UNITED STATES PATENT AND TRADEMARK OFFICE

10/561,736

Office Action Summary	Application No. 10/561,736	Applicant(s) VOGELBACHER ET AL.	
	Examiner MARIA VERONICA D. EWALD	Art Unit 1791

DETAILED ACTION

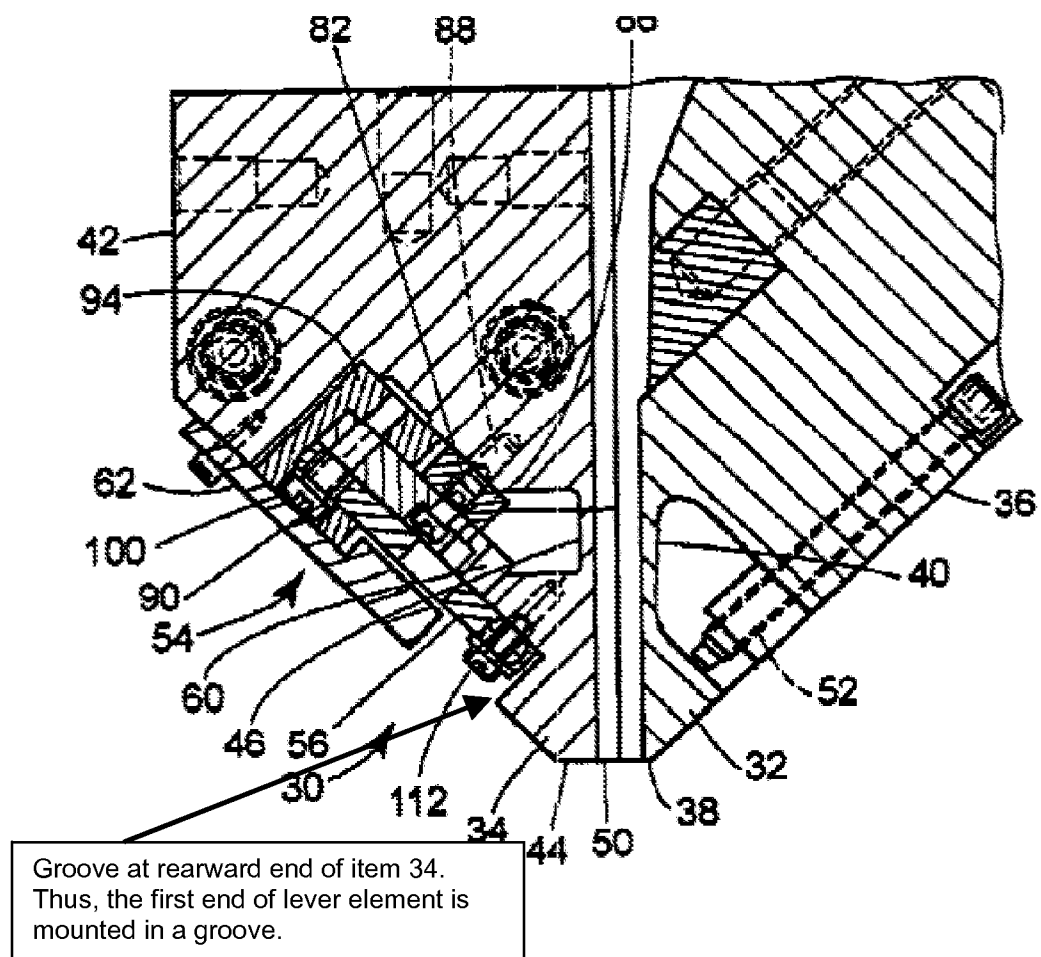
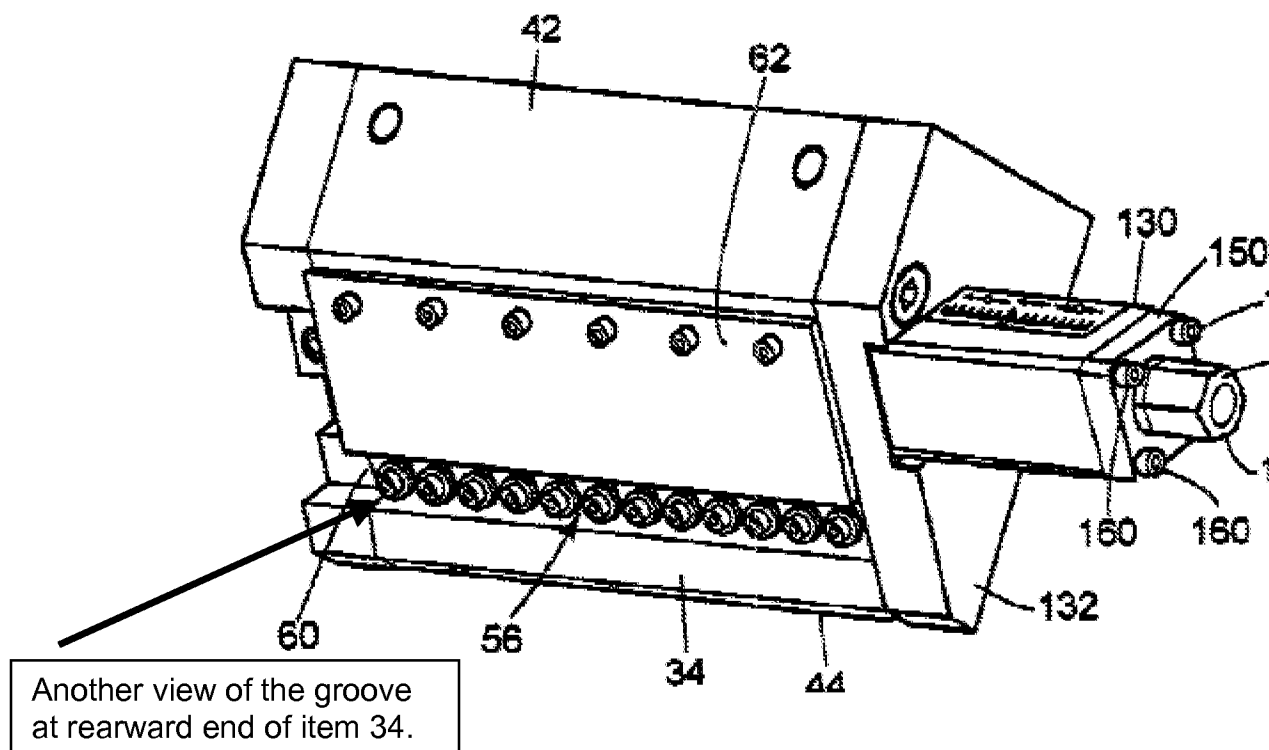
With respect to the reference of Ulcej, however, the Examiner disagrees with the assertion that Ulcej does not teach a groove. A groove, by definition can be a furrow, a channel or a gouge. Ulcej teaches such an element or gouge as shown in the figure

below:

Thus, the Examiner maintains the rejection with respect to the reference of Ulcej.
